### FINAL UNIT (X45-391x-xx, X45-398x-xx) Component side view

## TX-RX UNIT (X57-785x-xx, X57-861x-xx) Component side view

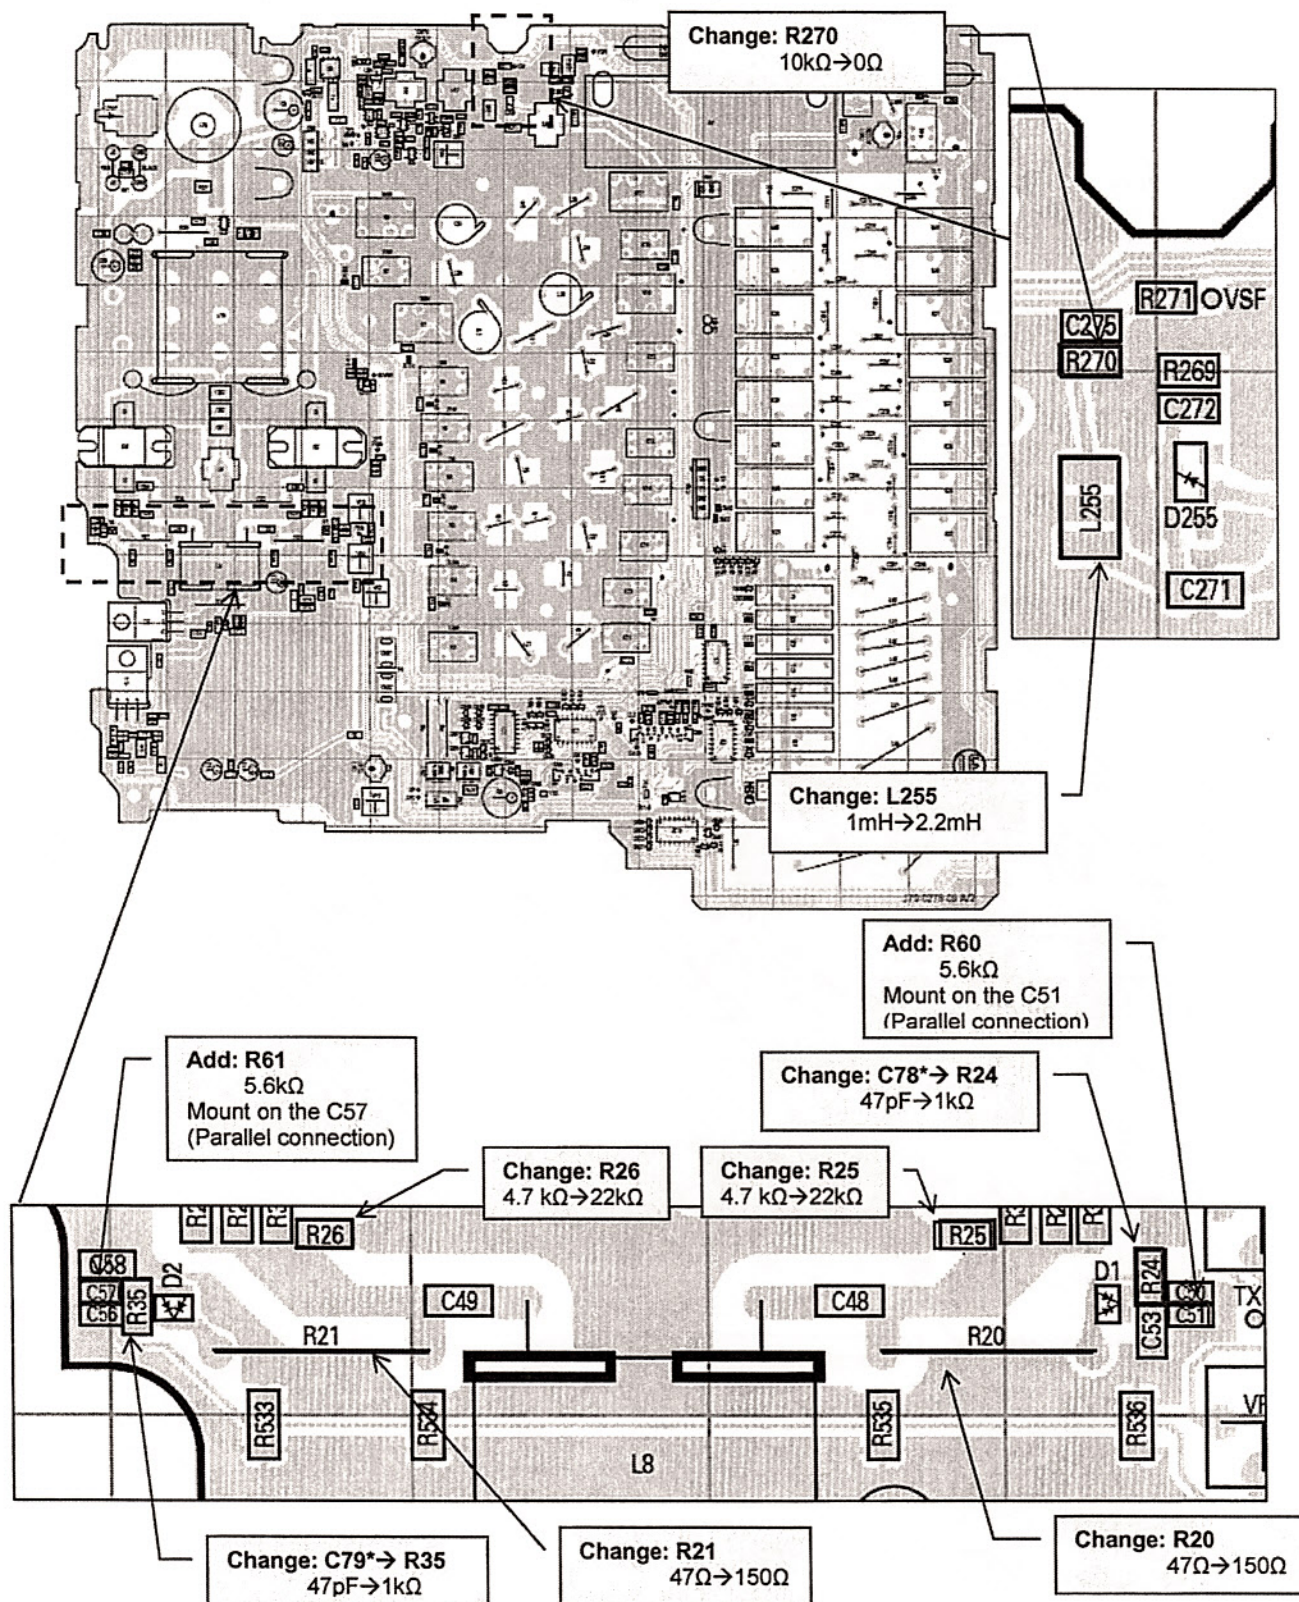
\*In the service manual, 2 x RK73FB2B471J (470Ω) resistors are listed at the location of R24, R35 instead of the actually mounted C78,C79 (47pF). Please replace these capacitors with 1kΩ resistors.

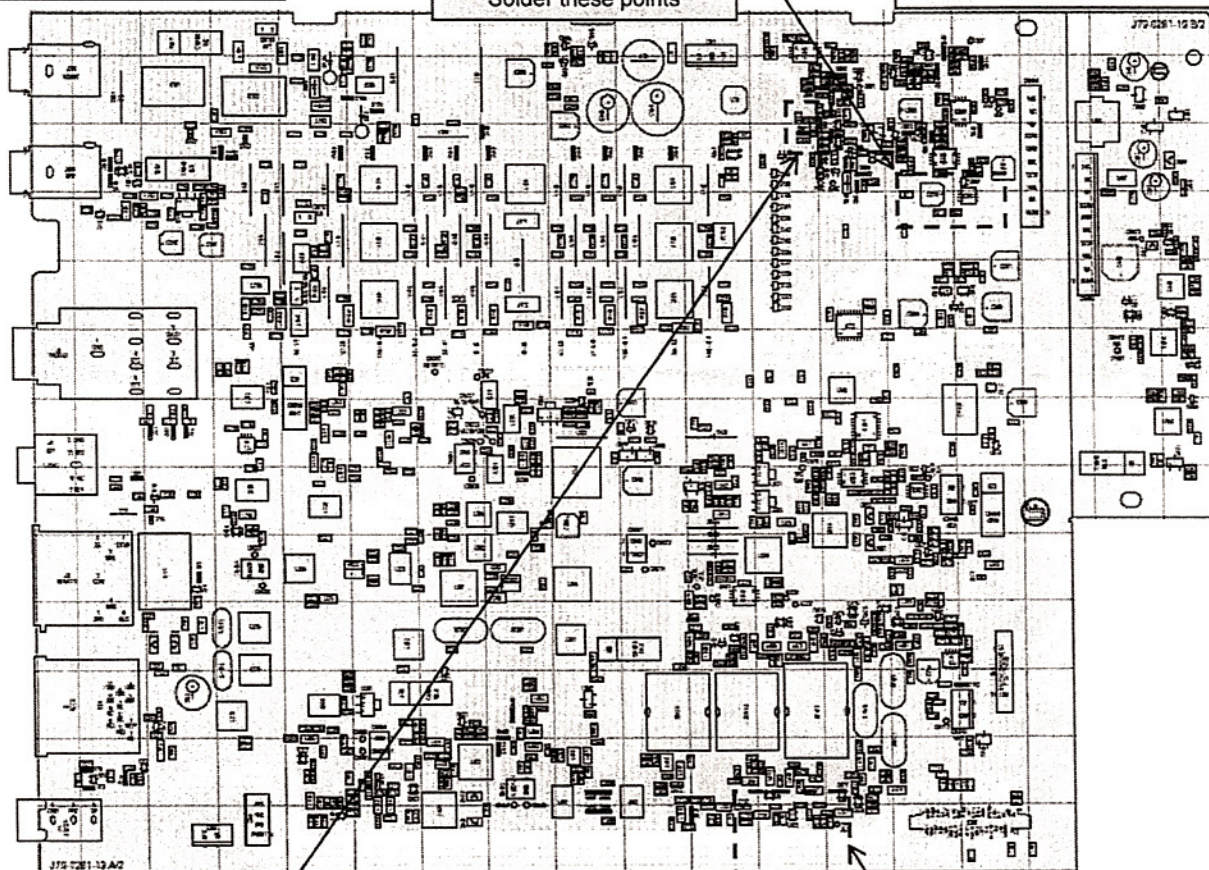
Change: C810  
10 $\mu$ F  $\rightarrow$  1 $\mu$ F

Delete (Move): C815  
0.047 $\mu$ F  $\rightarrow$  None  
(Do not reuse the removed part for  
the new location of the C815)

Add (Move): C815  
0.047 $\mu$ F  
Mount on the R817  
(Parallel connection)

Change: R825  
100k  $\Omega$   $\rightarrow$  220k

Add: R861  
47 $\Omega$   
(Serial connection with the C830)

Add: Insulation sheet  
F20-3320-04

Add: C830  
0.47 $\mu$ F  
(Serial connection with the R861)

Solder these points

Change: R809  
1.8k $\Omega$   $\rightarrow$  2.2k $\Omega$

Change: R807  
4.7k $\Omega$   $\rightarrow$  3.3k $\Omega$

Change: D801  
5.1V  $\rightarrow$  6.2V

Change: R728  
330 $\Omega$   $\rightarrow$  100 $\Omega$

Change: R734  
22k $\Omega$   $\rightarrow$  1k $\Omega$
